project
Black Country Retrofit Wrap and Associated Works
100 - 122 Darlaston Road, Kings Hill, WS10 7SR

title
Window Head Detail

job	dwg no	rev	date	date
18-1540	510	A	Jul 20	Jul 20
			scale	scale
			drawn	drawn
			1:5 @ A3	1:5 @ A3
			RP	RP

Window Head Detail Cementitious Cladding

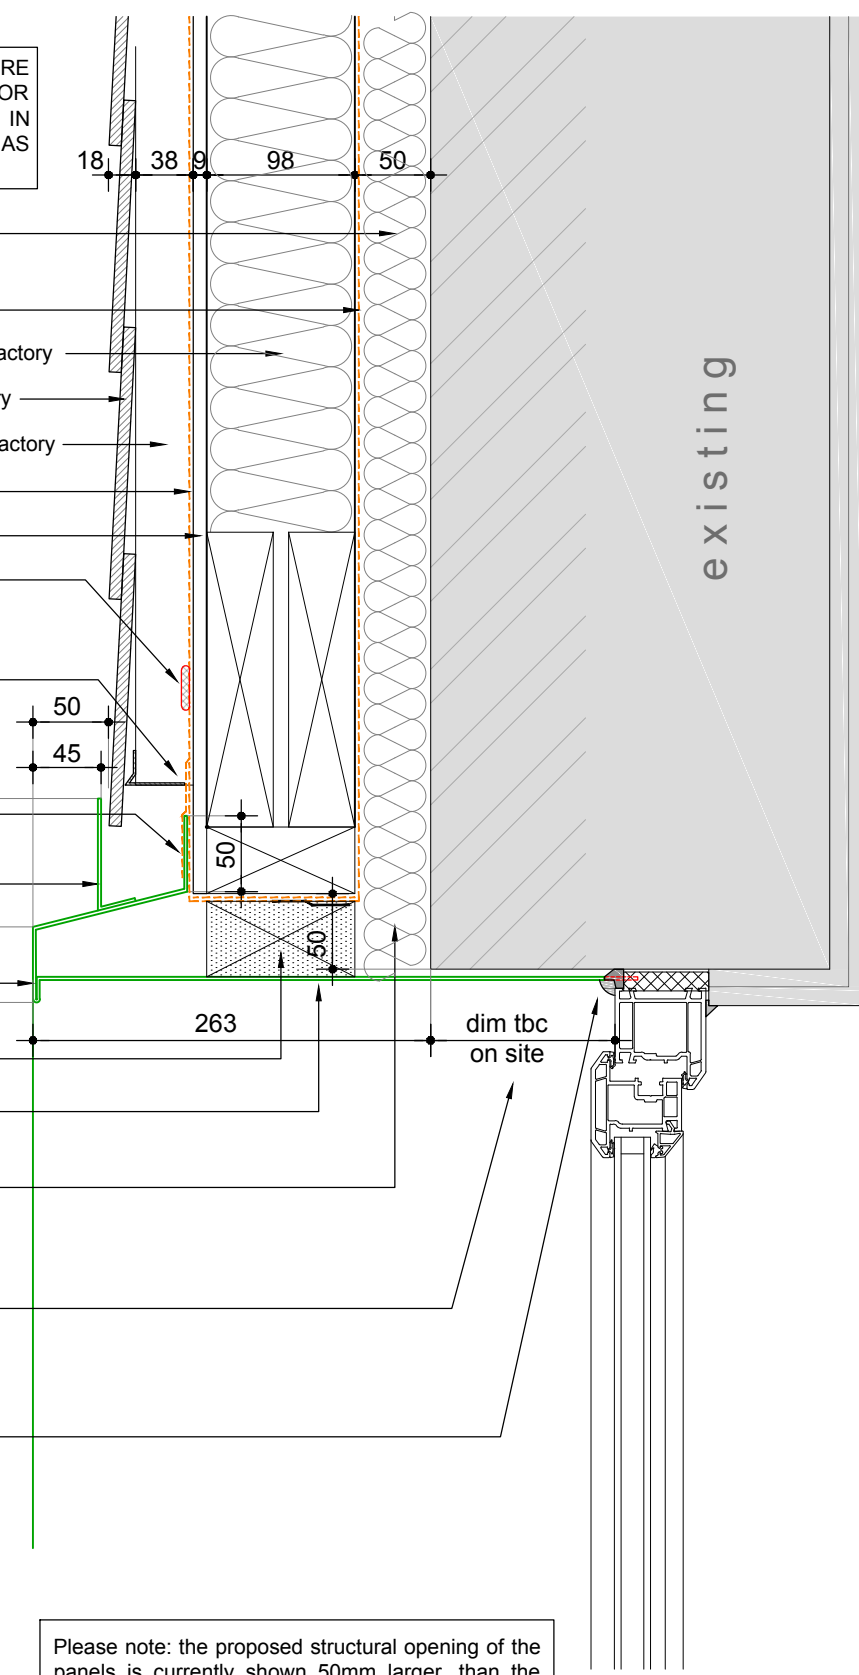
A Aluminium profile revised and insulation added to external face of existing wall. Dwg no. revised 22/08/20 RP
